**PROPOSED REDEVELOPMENT OF  
HEYTHROP COLLEGE, KENSINGTON**

**TRANSPORT REVIEW (OBJECTION)**

**(Zipporah Lisle-Mainwaring)**

TTHC Ref: M18095-01A  
Date: October 2018

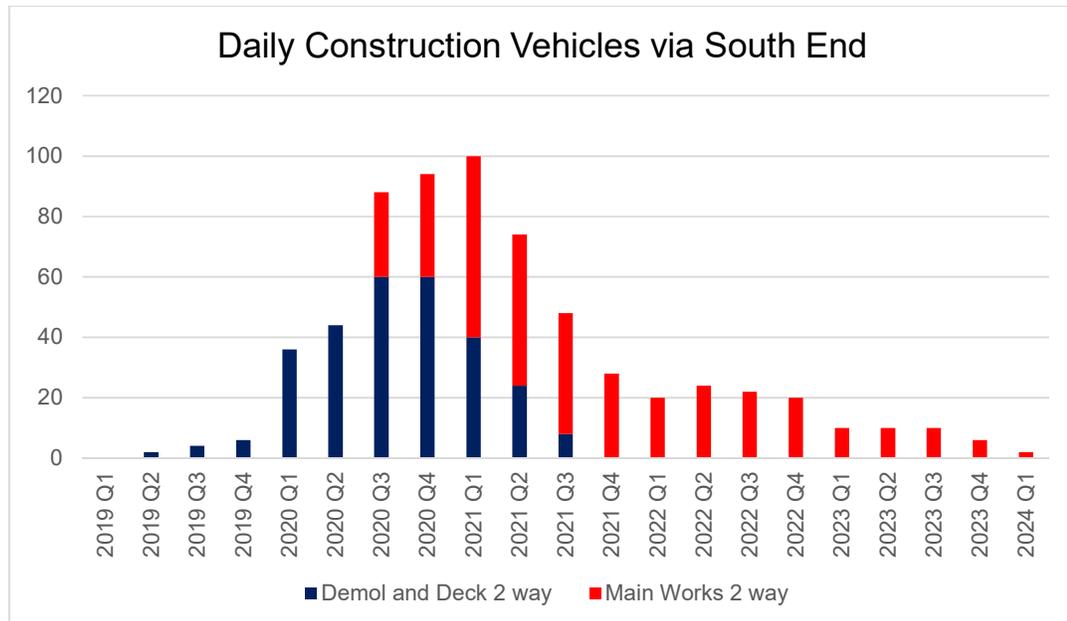
- 4.4 The CEMP suggests that construction vehicles would route from the A315 Kensington Road via Victoria Road, St Albans Grove and South End to the existing access gate into the Site. The overall length of the proposed access route from Kensington Road into the Site is 0.57km.

- 4.5 These streets are predominantly residential in character; during the daytime period there are more pedestrian and cycle movements than vehicle movements. Consequently, the geometry along this route is fairly restrictive:

the typical carriageway width on St Albans Grove is around 6.0m (including on-street parking), and the kerb radii at junctions are as small as 2m.
